# **Awel y Môr Offshore Wind Farm**

## **Applicant's Response to the Examining Authority's Third Written Questions**

### **Deadline 7**

**Date: 08 March 2023**

**FIGURE TITLE:** APPENDIX B - RESPONSE TO ExA3 Q9.8  
 PREDICTIVE AGRICULTURAL LAND CLASSIFICATION (ALC) AND 2023 ALC SURVEY RESULTS

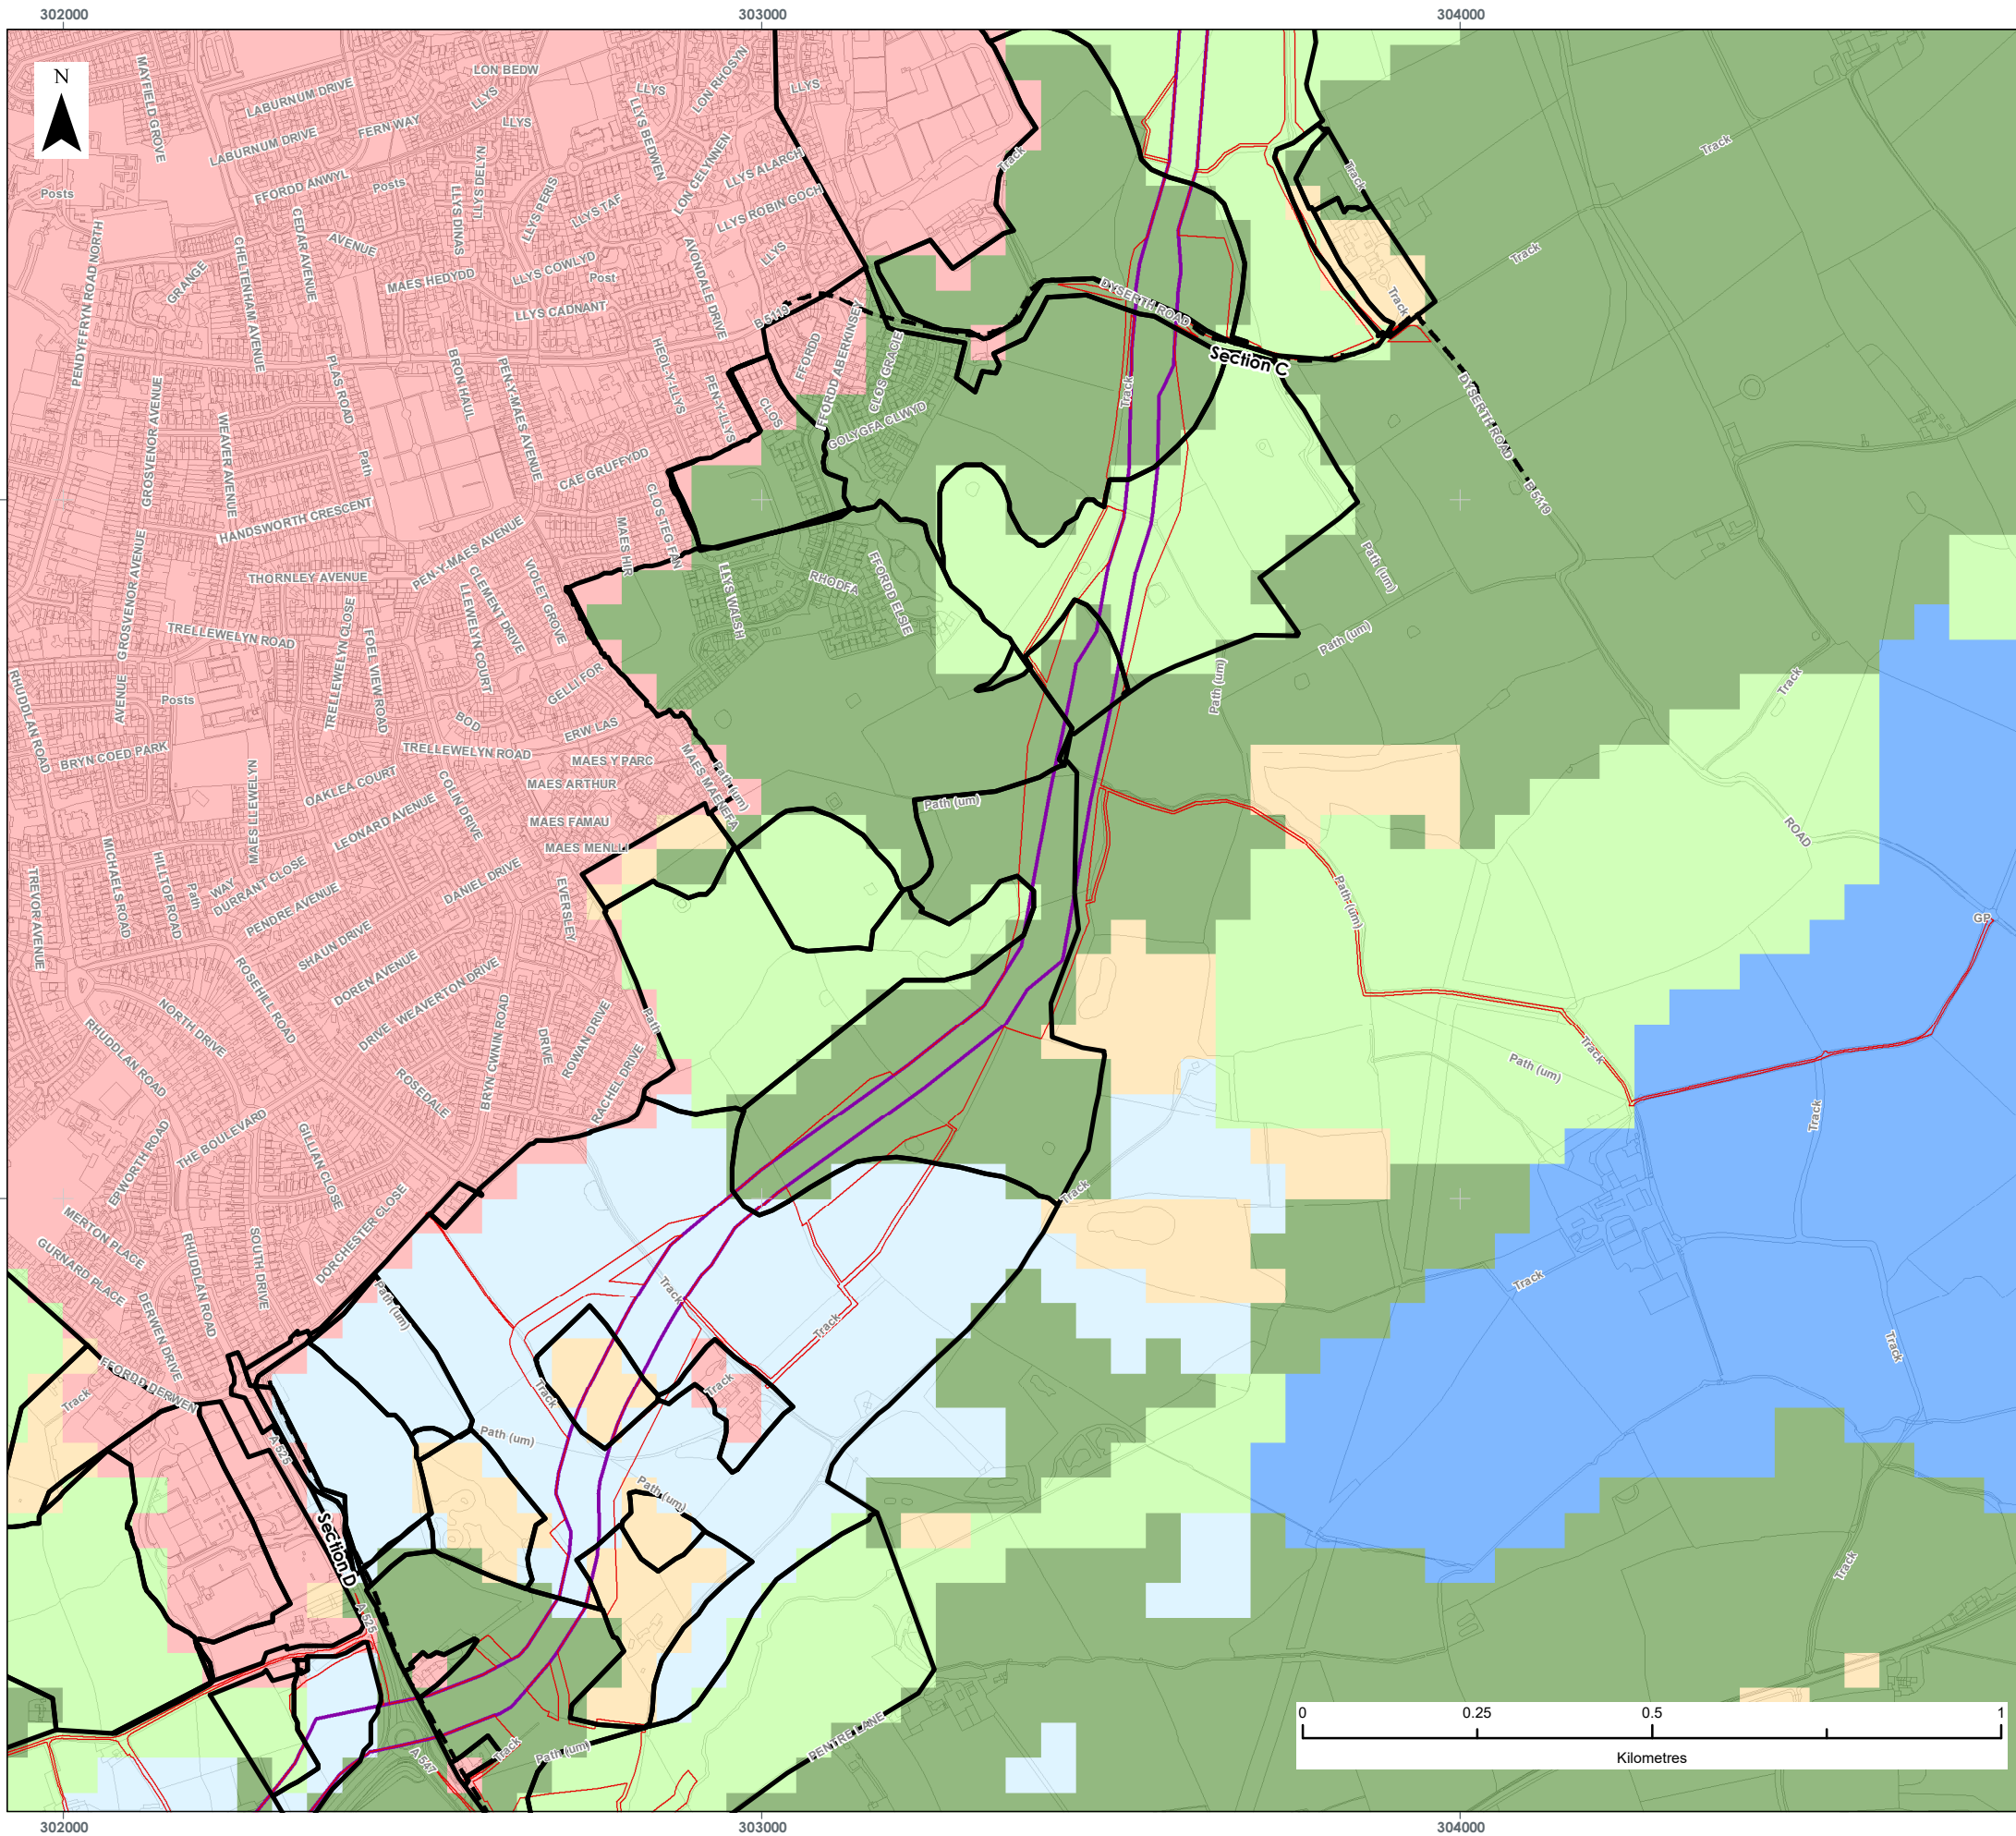
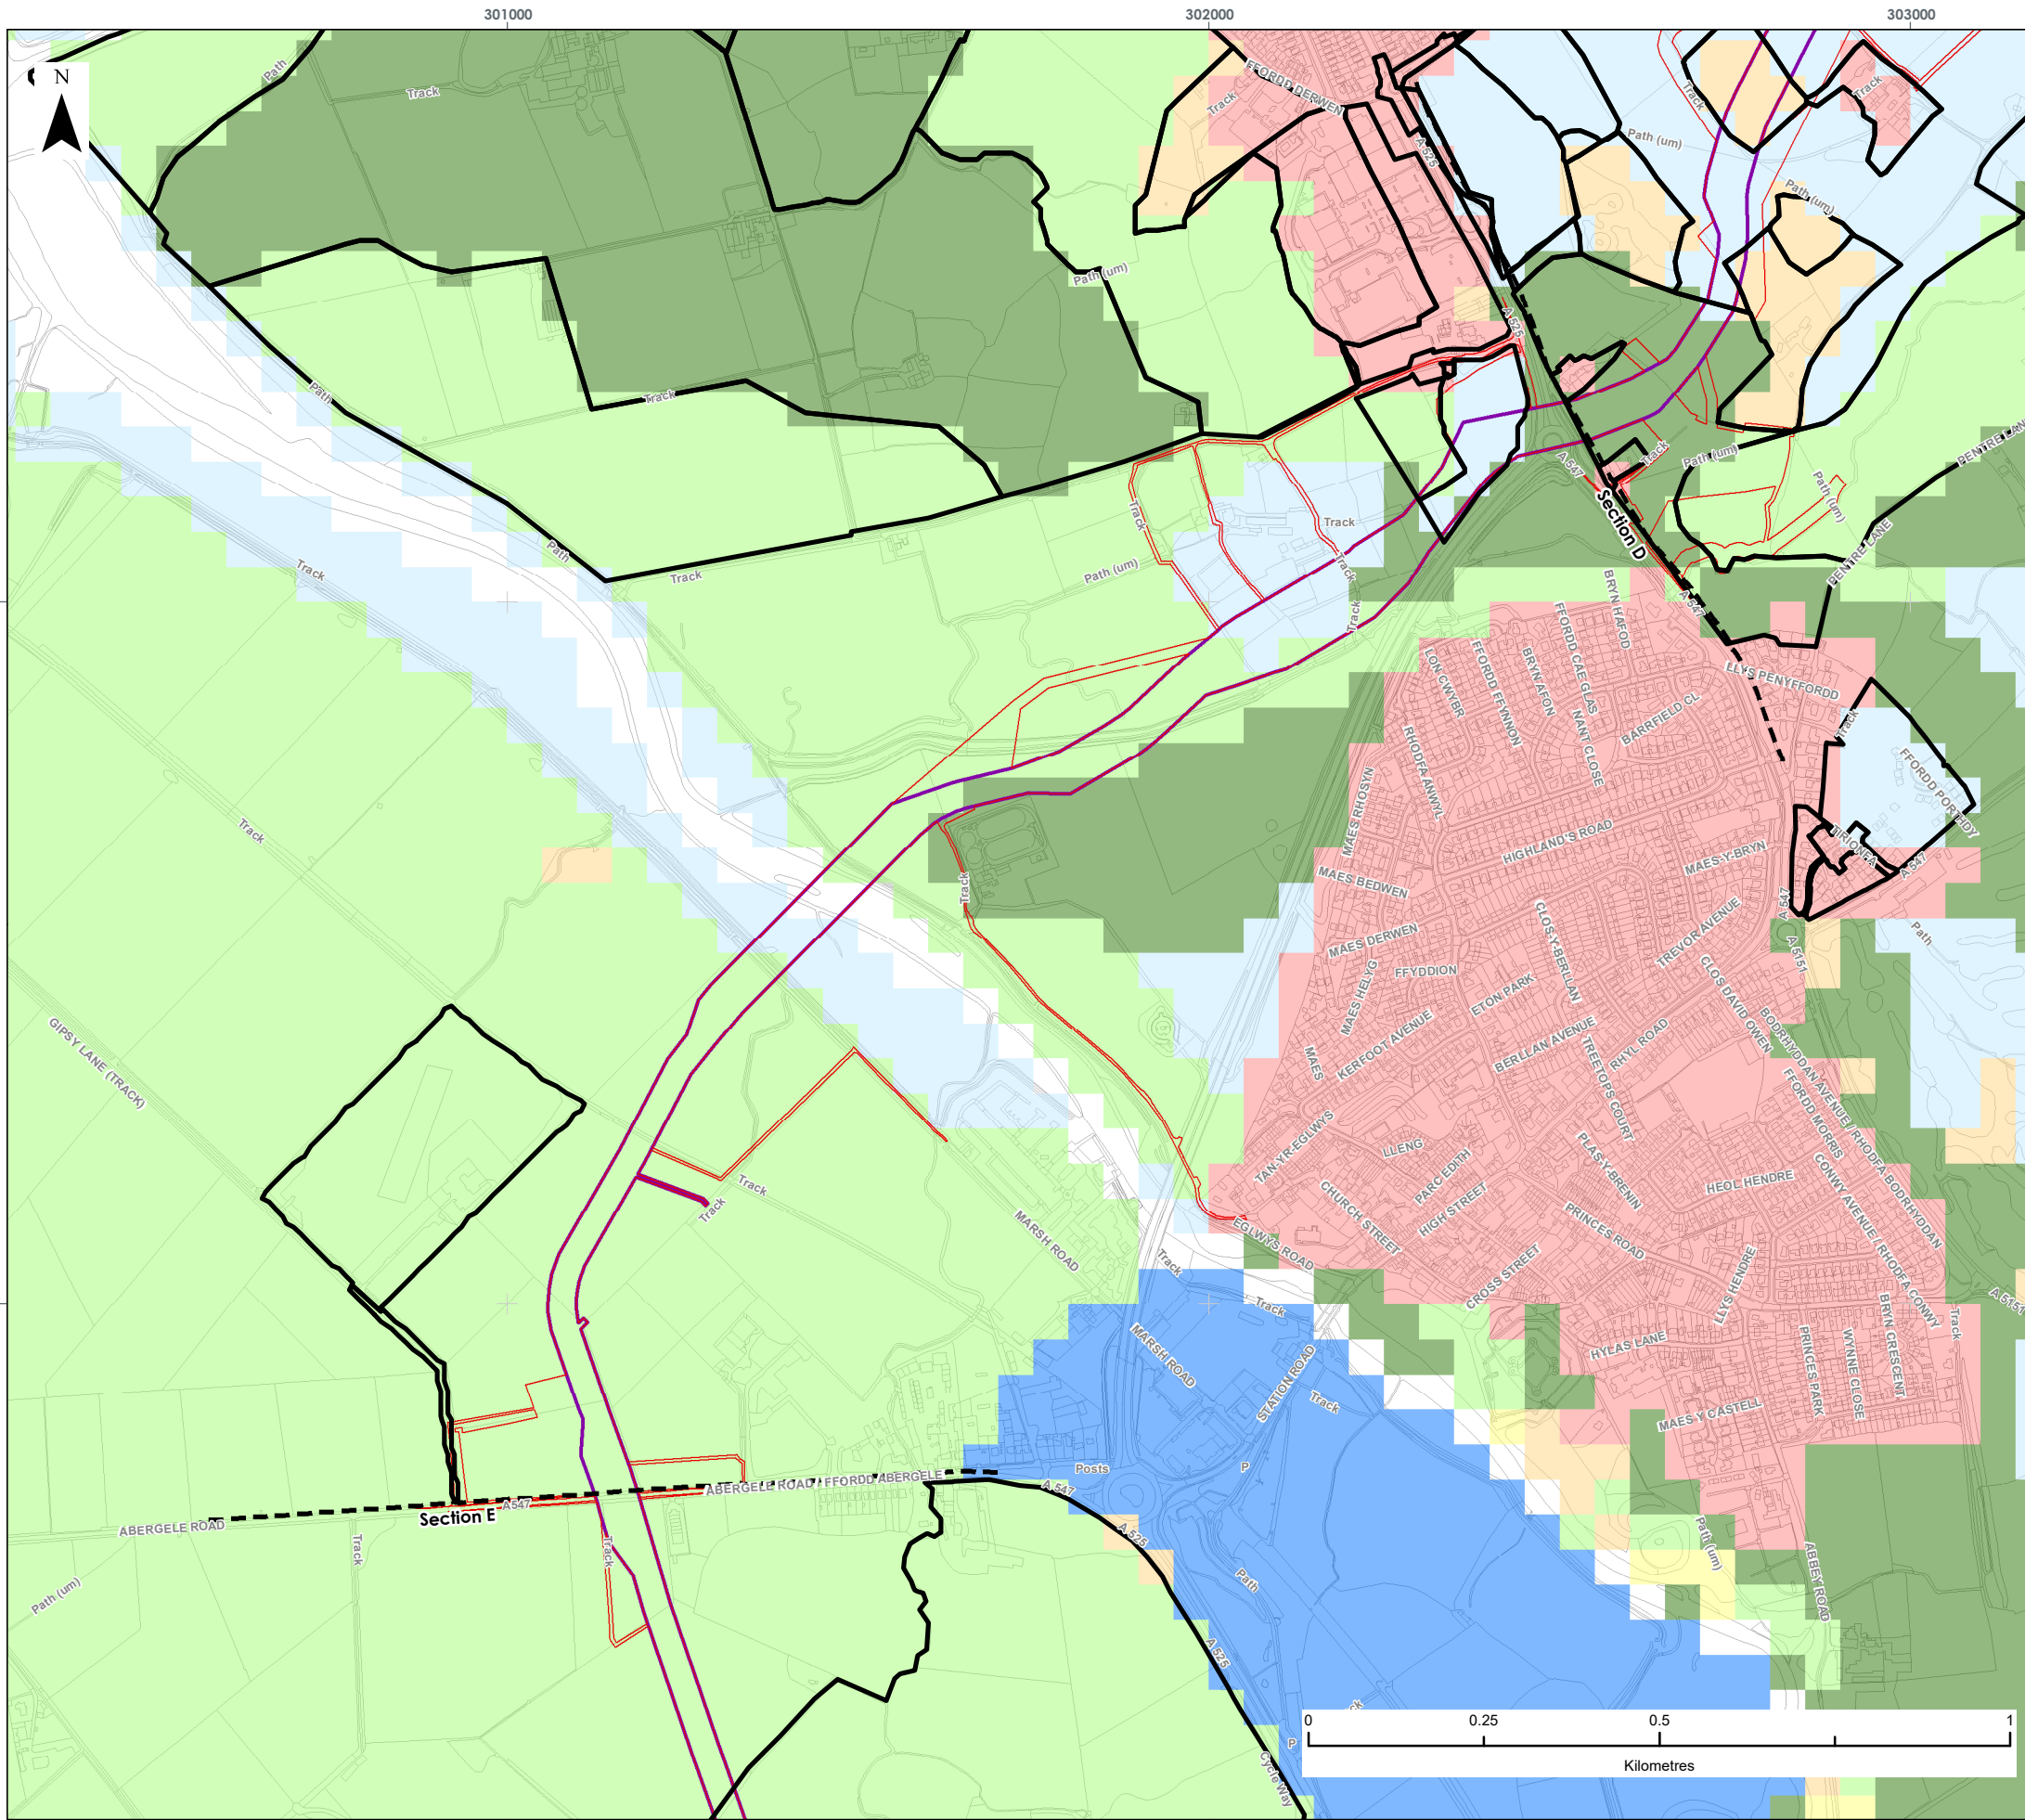
QUESTION NUMBER	QUESTION ADDRESSED TO	QUESTION	APPLICANT'S RESPONSE																											
	Farming Company																													
9.6	Applicant	<p><b>Onshore Substation Site (OnSS)</b></p> <p>Noting that a further Agricultural Land Classification (ALC) survey has been undertaken at the proposed OnSS site, is it necessary to update the table provided in response to ExQ1.9.8 [REP1- 007]?</p>	<p>The Applicant has updated the table to incorporate the results of the 2023 Agricultural Land Classification (ALC) survey as follows:</p> <p>The area of the OnSS footprint and wider landscape mitigation and ecological compensation and enhancement area (Plot 417), includes 1.5 Ha of Grade 3a which represents 0.69% of Grade 3a within 1000m of OnSS and 0.011% of Grade 3a land in Denbighshire.</p>
